# Final Environmental Impact Statement (FEIS)

Neelytown Business Park  
Tax Lots 36-1-33, 36-1-11.221, 36-1-11.23, 36-1-11.212,  
36-1-11.211, 36-1-11.1, 36-1-10.1, and 33-1-91  
Town of Montgomery, Orange County, NY  
SEQRA Classification: Type 1

June 27, 2025; Last revised: June 19, 2026

Project No. 21000327A

**Figure 2: Surrounding Land Uses Changes to the Project**

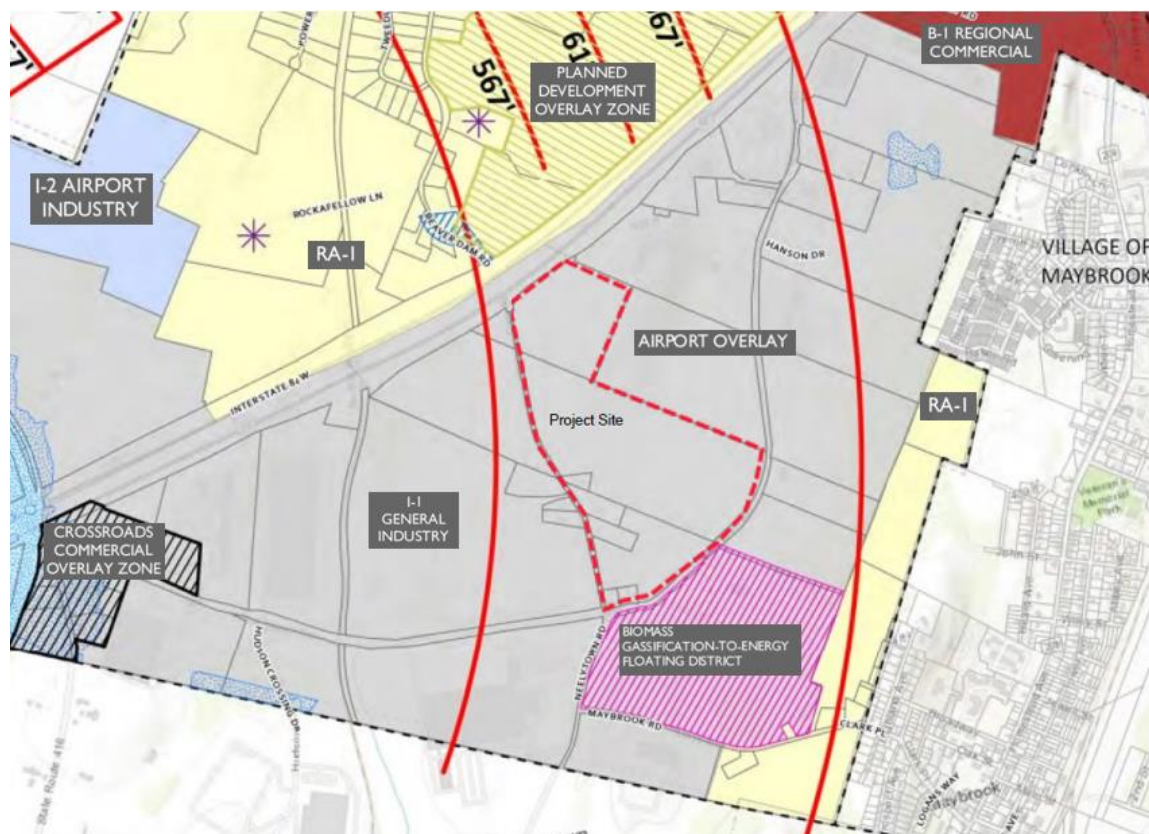
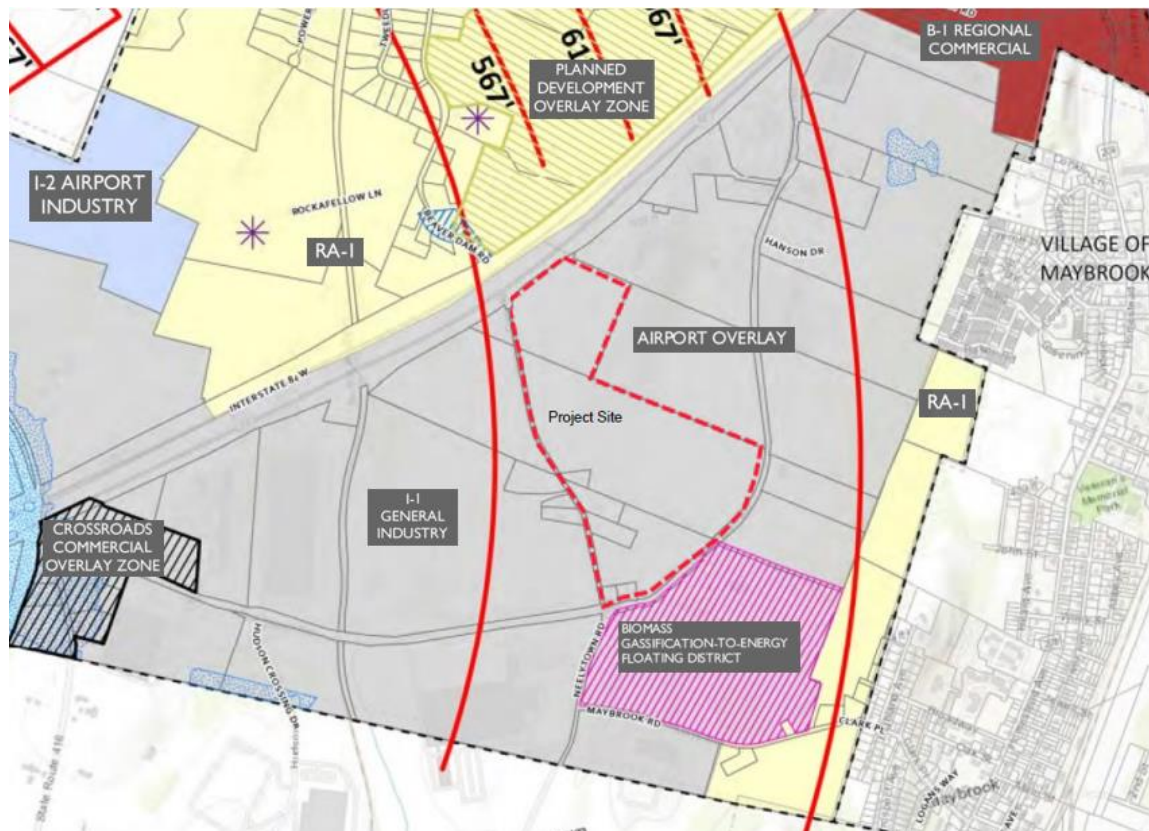
Pg. 6 Comment: Figure 2 shows zoning, not surrounding land uses. Same thing regarding Figure 1. Amend figures. This comment is not addressed – insert a land use figure for one of the images, and caption the other as the zoning map.

**Response: The surrounding landuse map has been added to Figure 2 in addition to the zoning map. This can also be found within Appendix O.**
